**COUNTY OF SAN MATEO
PLANNING AND BUILDING DEPARTMENT**

SUBJECT: EXECUTIVE SUMMARY: Consideration of a Coastal Development Permit and Design Review to construct a new 2,550 sq. ft., 2-story, single-family residence, plus an attached 400 sq. ft. 2-car garage, on an existing 6,993 sq. ft. undeveloped, legal non-conforming parcel, on San Ramon Avenue, in the unincorporated Moss Beach area of San Mateo County. No trees are proposed for removal. This project is appealable to the California Coastal Commission.

County File Number: PLN 2014-00007 (Abdulqader)

SITE PLAN

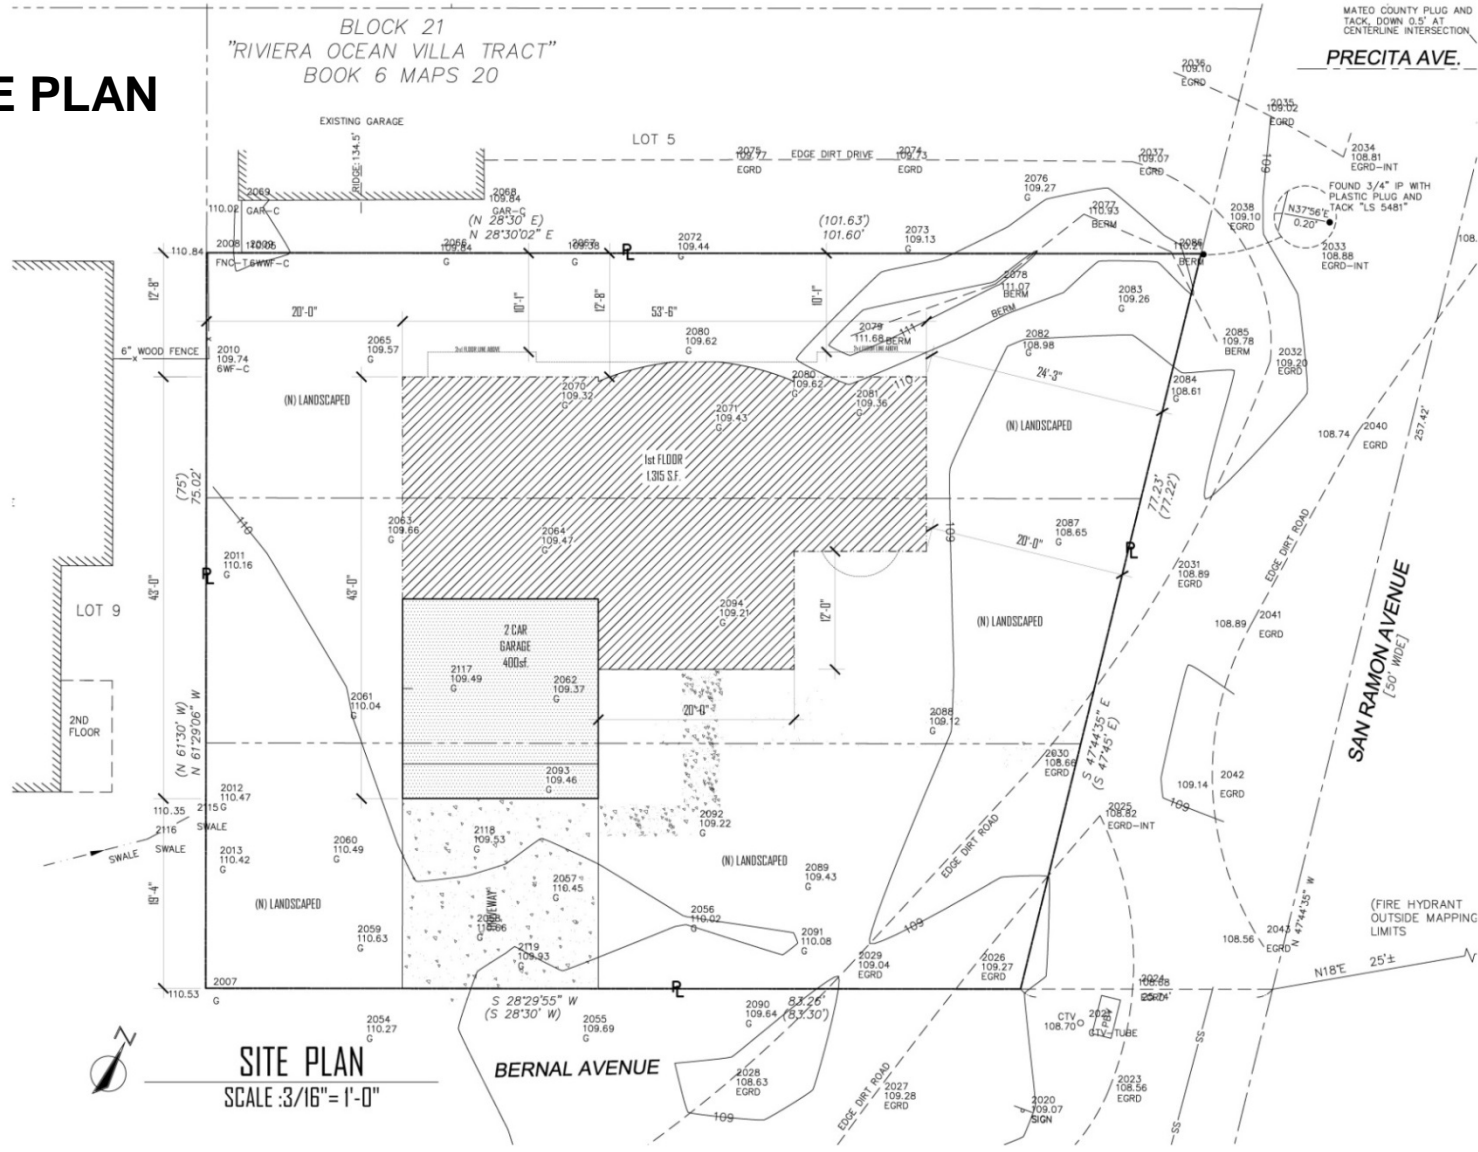
38. Show location of fire hydrant on a site plan. A fire hydrant is required within 250 feet of the building and flow a minimum of 1,000 gpm at 20 psi. This information is to be verified by the water purveyor in a letter initiated by the applicant and sent to San Mateo County Fire/Cal-Fire or Coastside Fire District. If there is not a hydrant within 250 feet with the required flow, one will have to be installed at the applicant's expense.
39. All fire conditions and requirements must be incorporated into your building plans prior to building permit issuance. It is your responsibility to notify your contractor, architect and engineer of these requirements.

- Show location of fire hydrant on a site plan. A fire hydrant is required within 250 feet of the building and flow a minimum of 1000 gpm at 20 psi. This information is to be verified by the water purveyor in a letter initiated by the applicant and sent to San Mateo County Fire/CAL Fire or Coastside Fire District. If there is not a hydrant within 250 feet with the required flow, one will have to be installed at the applicant's expense.
- All fire conditions and requirements must be incorporated into your building plans, (see attached conditions) prior to building permit issuance. It is your responsibility to notify your contractor, architect and engineer of these requirements.

SOUTH ELEVATION

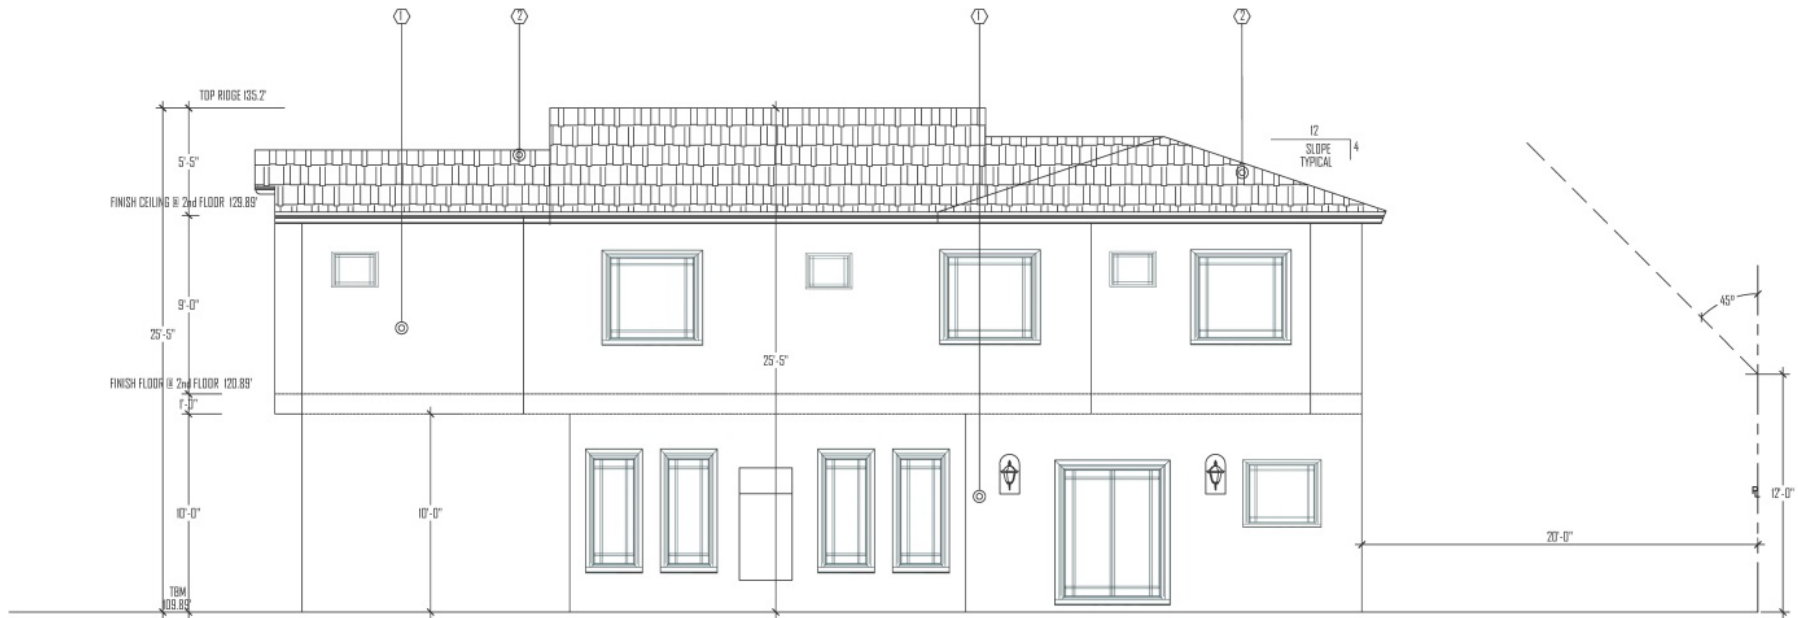
south elevation façade, further enhanced by the reduction in size of the entry area windows (Section 6565.20(D)2c).

ROOF PLAN

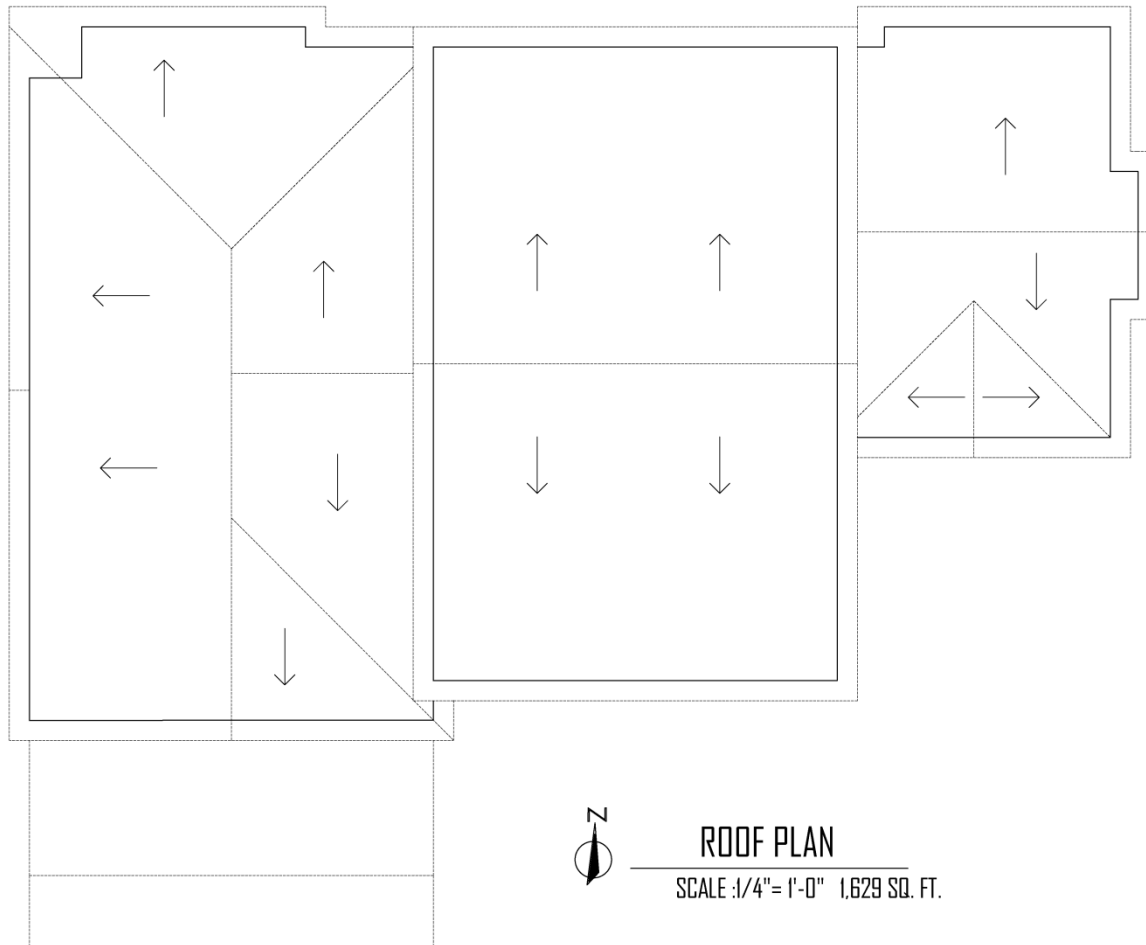
- (5) The revised roof form exemplified by the combination of hips and gables further enhances the design of the new home, while at the same time serving both as a mitigating factor relative to mass and bulk and a unifying element for neighborhood roof form compatibility (Section 6565.20(D)3).

- e. The revised roof form exemplified by the combination of hips and gables further enhances the design of the new home, while at the same time serving both as a mitigating factor relative to mass and bulk and a unifying element for neighborhood roof form compatibility (Section 6565.20(D)3).

LANDSCAPING PLAN

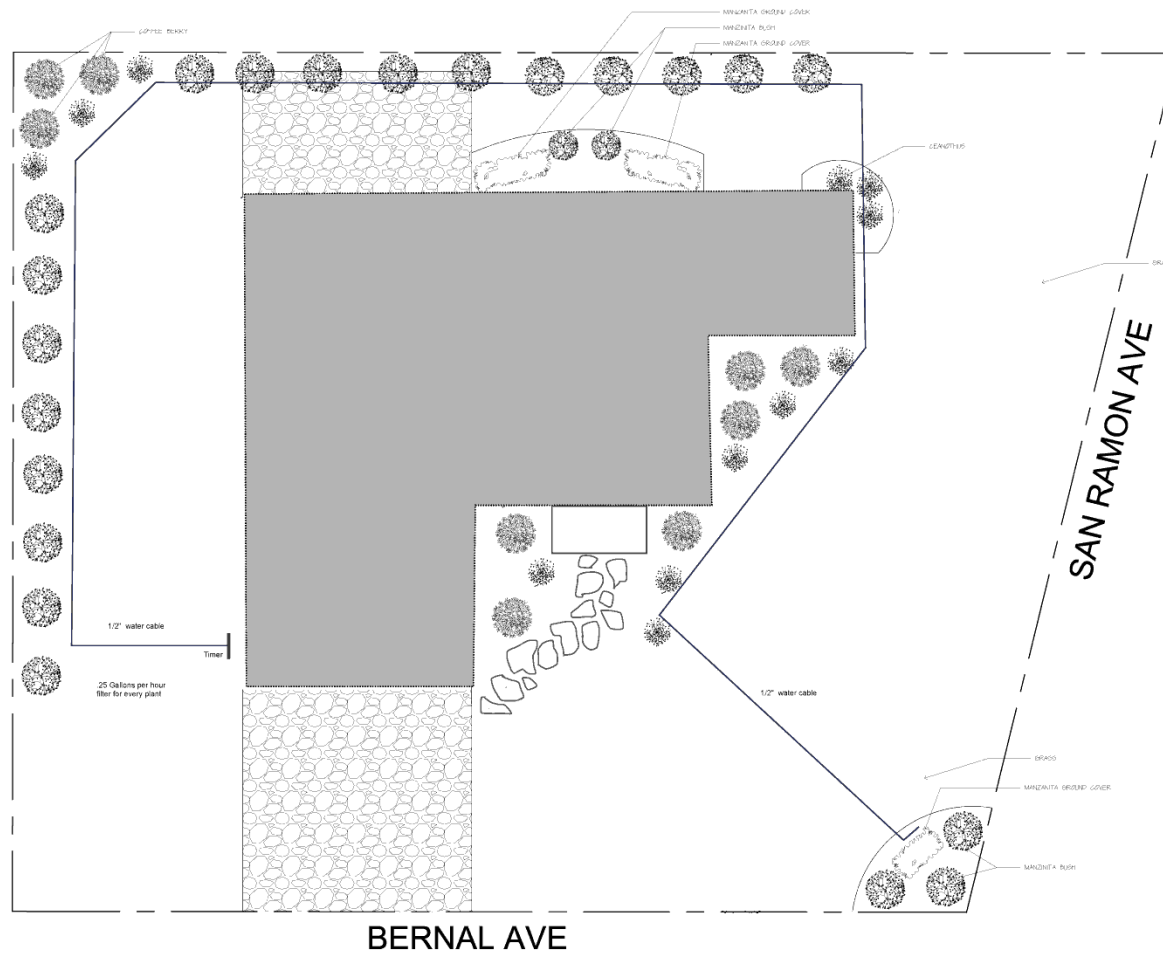
Comprehensive landscaping plan that shows a less static appearance so as to mimic/complement the natural surroundings that incorporates drought tolerant, native and non-invasive species, calling out the removal of existing ice plants on-site.
5. The applicant shall provide "finished floor elevation verification" to certify that the structure is actually constructed at the height shown on the submitted plans. The applicant shall have a licensed land surveyor or engineer establish a baseline elevation datum point in the vicinity of the construction site.
 - a. The applicant shall maintain the datum point so that it will not be disturbed by the proposed construction activities until final approval of the building permit.
 - b. This datum point and its elevation shall be shown on the submitted site plan. This datum point shall be used during construction to verify the elevation of

- a. Comprehensive landscaping plan that shows a less static appearance so as to mimic/complement the natural surroundings that incorporates drought tolerant, native and non-invasive species, calling out the removal of existing ice plants on-site.
